DS-K5603-Z Face Recognition Terminal

V1.1build180827 Release Notes

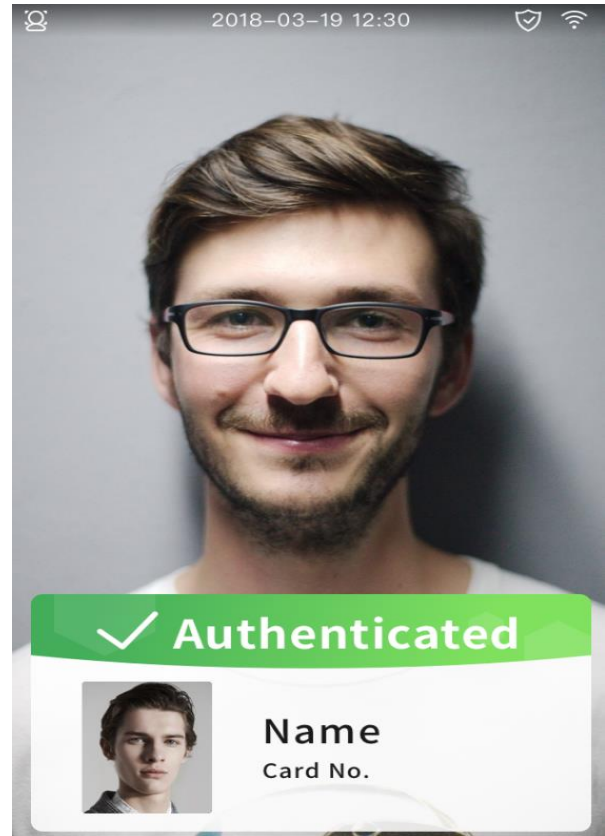
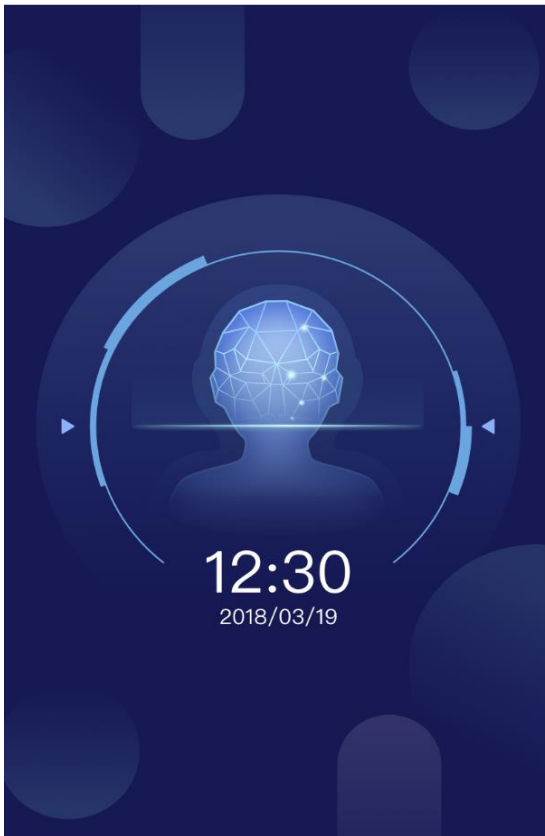
1. Improved face recognition algorithm and live face detection algorithm. When upgrade from V1.0 firmware to V1.1, all face pictures information will be re-modeled. If re-model failed for particular face picture, the information will up load to client software.
2. New UI style design.(Examples: standby mode UI and full screen authentication UI)

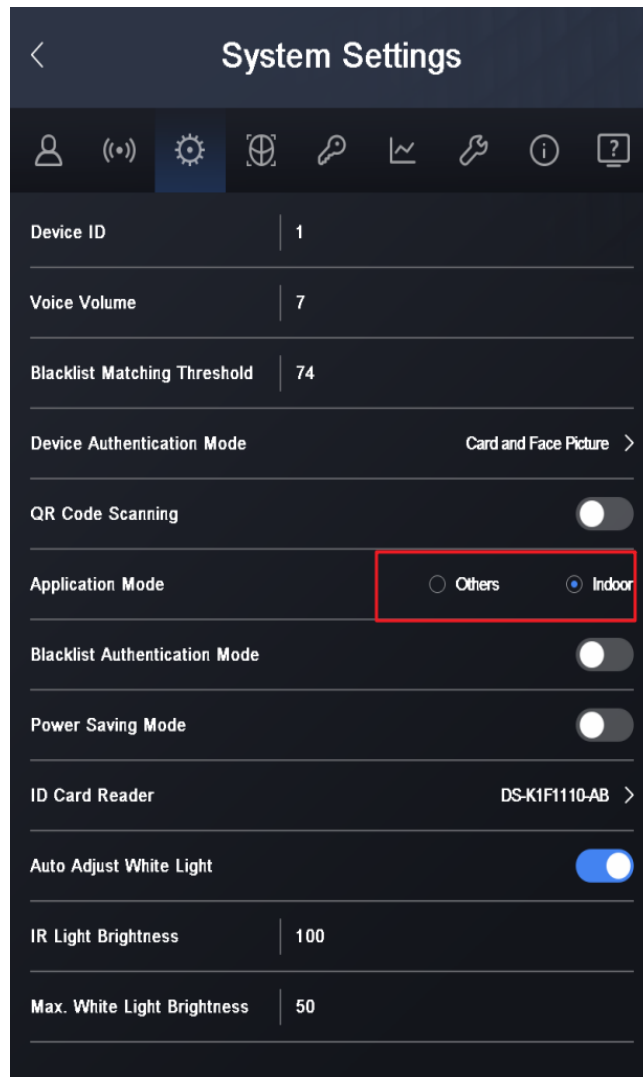
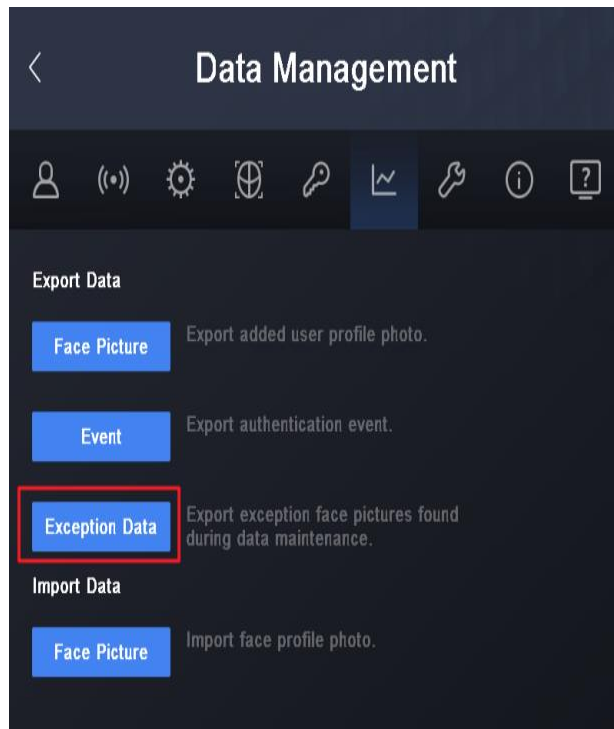
3. After activating the device, you can select **Indoor** or **Others** application mode for better device application. You can also change the application mode in System Settings later.

4. When you use virtual keyboard, now you don't need to quit virtual keyboard first to click other button, other button are always ready to click.
5. **Default Settings** will delete all user information while keep all events information.
6. When using Ehome communication, device still support apply, get, delete or remote collect face picture by client software.
7. Face picture and modeling information can applied simultaneously.
8. If someone try a user's face photo too many times when live face detection is on, the device will lock this user's face, you need wait 5 minutes or use real face to successfully authenticate 3 times to unlock this user.
9. If put upgrade firmware in USB disk, device will upgrade automatically when power on.
10. On Standby mode, screen will show date and time status.
11. Add '**Exception Data**' icon to export exception data to the USB flash drive.

12. Add 'System Information' tag  to view the total capacity and the usage of the face pictures, card, event, and fingerprint;
13. You can check device name, the software version, the firmware version, and the open source code license in 'Device Information' tag .
